**ITEM 4. DEVELOPMENT APPLICATION: 42-60 ROSEBERY AVENUE AND 94-100 AND 102 DALMENY AVENUE ROSEBERY****FILE NO. D/2014/526****DEVELOPMENT APPLICATION NO: D/2014/526****SUMMARY**

**Date of Submission:** 17 April 2014  
(Amended plans received 21 July 2014 and 30 July 2014)

**Applicant:** Karimbla Properties (No. 31)

**Figure 33:** Extract from SLEP 2012 Building Height (metres) with site identified

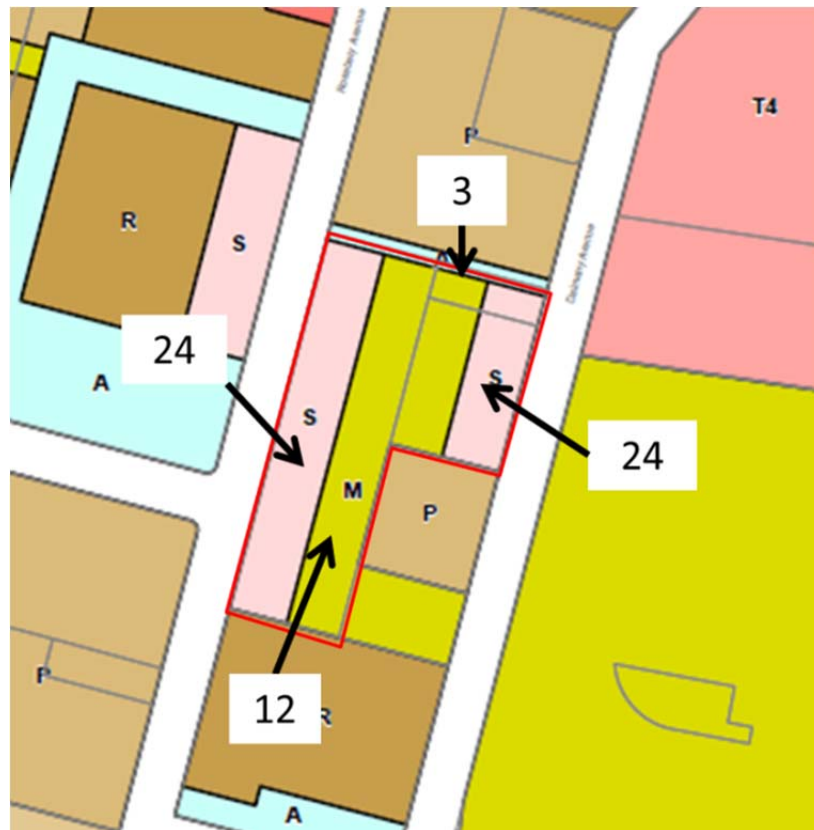
56. Clause 4.3 of the SLEP 2012 provides three different heights (3m, 12m and 24m) for the subject site which are illustrated in Figure 33 below.

- 57. The height of buildings B/C and E/F exceed the 24m height limit with lift overruns.
- 58. The applicant is relying on the provisions of Clause 4.6 of the SLEP 2012 to seek exception to the height development standard.

**Figure 34** Proposed childcare centre with extended area identified

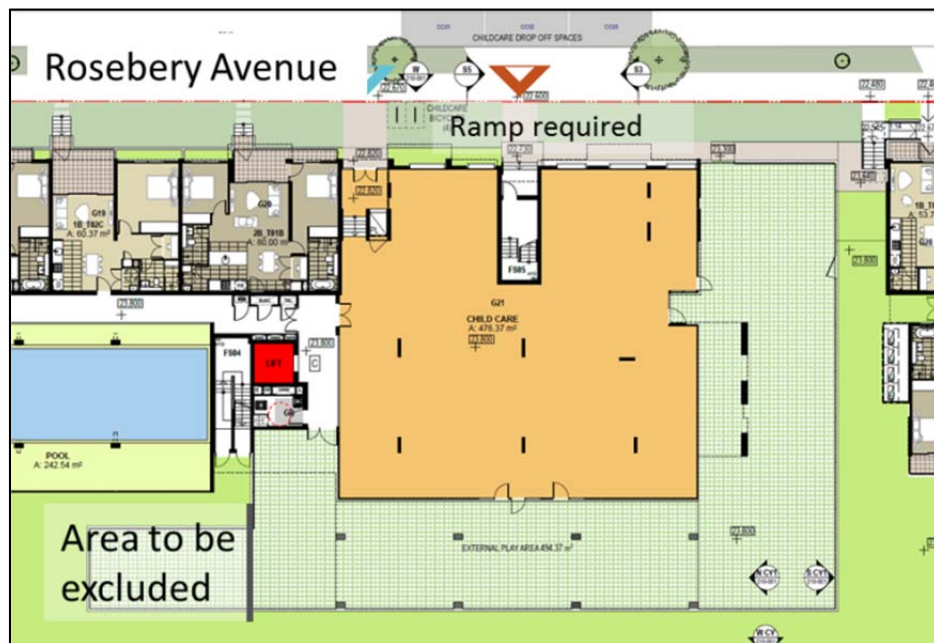
64. The childcare centre includes 476.37sqm internal area and 494.37sqm external area which is partly covered to provide sun shading. As part of recent amendments the outdoor area has been extended into the communal courtyard. It is recommended that this area be returned to the original configuration as the extended outdoor space would not be functional as shown in Figure 34.

65. The external area has an outlook to the two communal courtyards but is separated by fencing. It is unlikely that these areas will be capable of providing the best practice standard or minimum required space for the number of children proposed. It is recommended that no placement numbers be supported as part of the subject application.

Figure 35 Proposed drop off spaces for childcare centre in basement

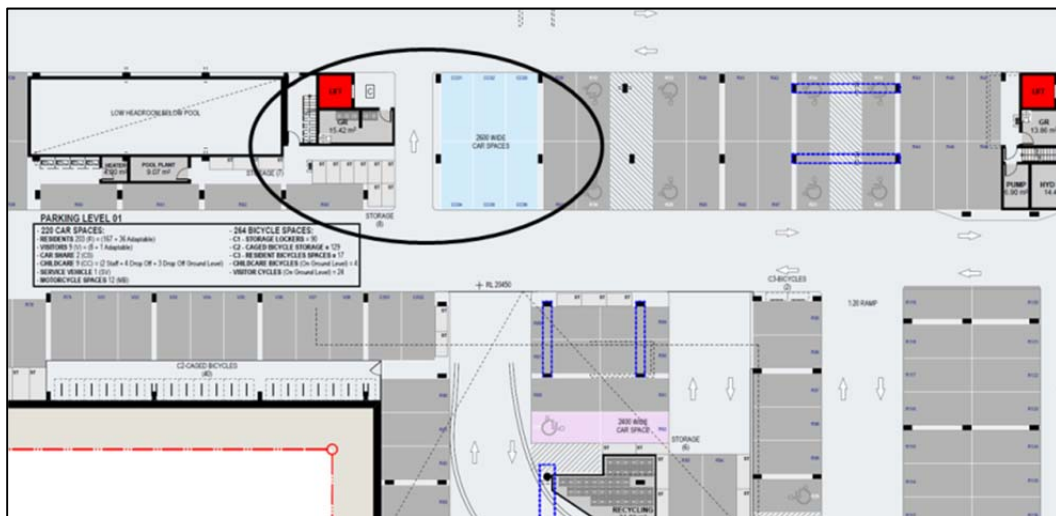
73. Direct lift access from the basement to the lobby outside the childcare centre is proposed however insufficient parking spaces have been proposed within the basement as shown in Figure 35 below.

74. It is recommended the basement plan be amended to include 6 drop off and pick up spaces and 2 staff car parking spaces as shown in Figure 36 below. Visitor parking could also be used drop off and pick up noting that it would be the responsibility of building management to ensure that visitor parking is not used permanently by residences.

Figure 40: Approximate location of tree 14 Dalmeny Avenue

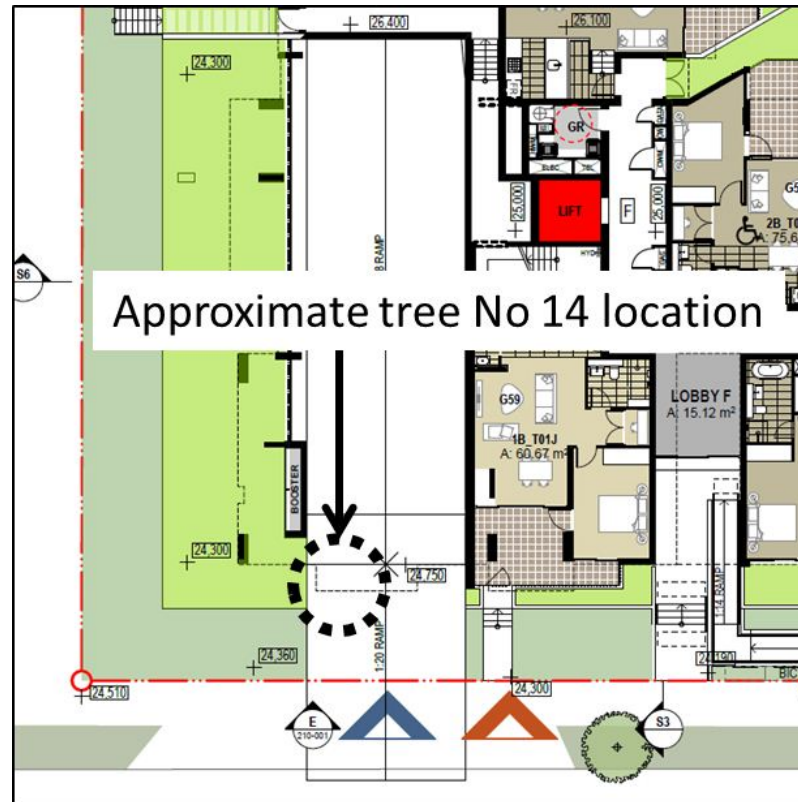
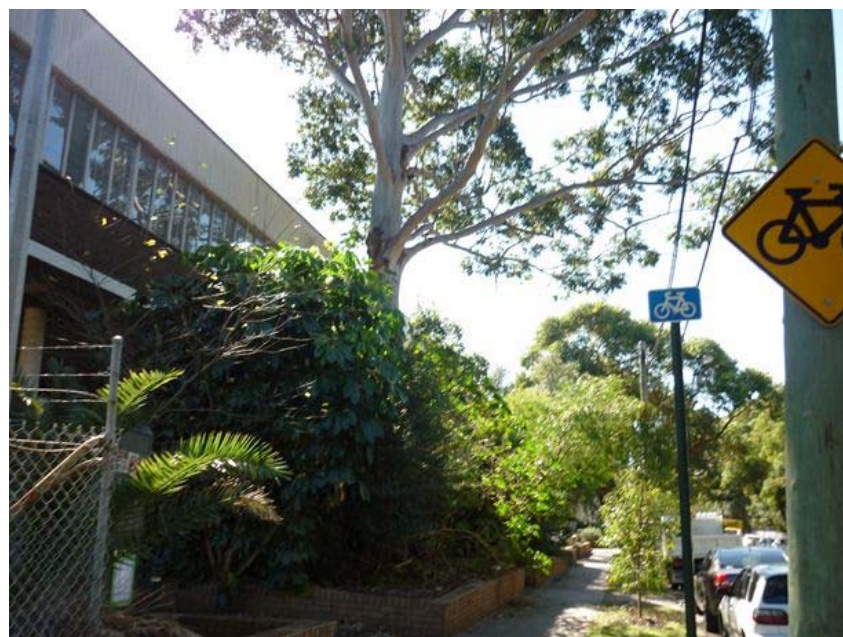
91. Tree No 14 is on the Dalmeny Avenue frontage and is a Sydney Blue Gum approximately 20m high. It is located on private land within an existing setback close to the south east boundary. It is proposed to remove this tree to accommodate the single driveway access to the basement as shown in Figure 40 below:
